## **Errata: KS8695PX Rev. A3**

Integrated Multi-Port PCI Gateway Solution

Device: KS8695PX  
Revision: A3  
Date: November 29, 2005  
Errata No.: ERR8695PX-112905

Figure 1 External I/O 8 bit system Interface

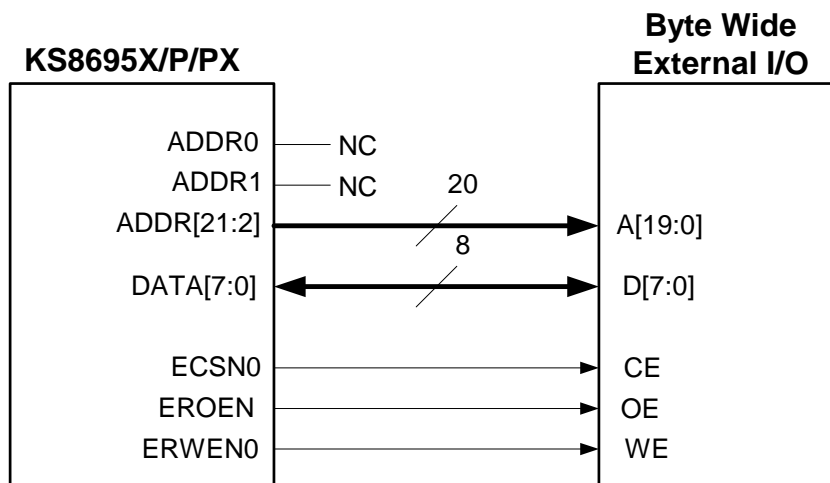
No.	Description	Workaround
1	Packets that have patterns matching the Ethernet IP type field in their payloads at a 32 byte increment may be incorrectly identified as an IP packet. Since the packet will not have a correct IP checksum, it will be dropped. The probability of packet drop is very low.	Turn off hardware IP filtering functions.
2	For packets <49 bytes, IP header checksum is not generated	Use software to pad packets to at least 49 bytes in length.
3	8 or 16-bit External I/O Port Read Access Extra Cycles. The external I/O controller and the static memory controller (NOR Flash and SRAM) share the same data bus and an internal read buffer used by ARM AHB interface for data transfer. The read buffer is 32-bit wide and on every read operation the buffer is filled with 32 bits of data. Therefore for 8 or 16-bit port interfaces there will be multiple read cycles to fill the 32-bit buffer. This is acceptable for static memory since extra cycles are used to cache the data and are harmless. However, extra cycles can possibly have side effects for certain external I/O devices such as inadvertent clearing of a pending interrupt. This particular problem does not exist for 32-bit ports since every access completes in a single cycle.	<p>For the External I/O, every read from an 8-bit port must be presented as a 32-bit interface. The following steps implement this procedure:</p> <ol style="list-style-type: none"><li>1. Program <b>ERGCON (register offset 0x4020)</b> bits [21:16] to 32-bit Data Width.</li><li>2. S/W shift address by 2 bit position to left: A3A2A1A0=0000 → 0000, =0001 → 0100, =0010 → 1000, etc.</li><li>3. H/W shift address bus by 2 bit position: A[21:0] → A[21:2]. See Figure 1 for illustration of system interface.</li></ol> <p>Every read from 16-bit port must be presented as 32-bit interface. Following steps implement this procedure:</p> <ol style="list-style-type: none"><li>1. Program <b>ERGCON (register offset 0x4020)</b> bits [21:16] to 32-bit Data Width.</li><li>2. S/W shift address by 1 bit position to left: A3A2A1A0=0000 → 0000, =0010 → 0100, =0100 → 1000, etc.</li><li>3. H/W shift address bus by 1 bit position: A[21:1] → A[21:2]. See Figure 2 for illustration of system interface.</li></ol>
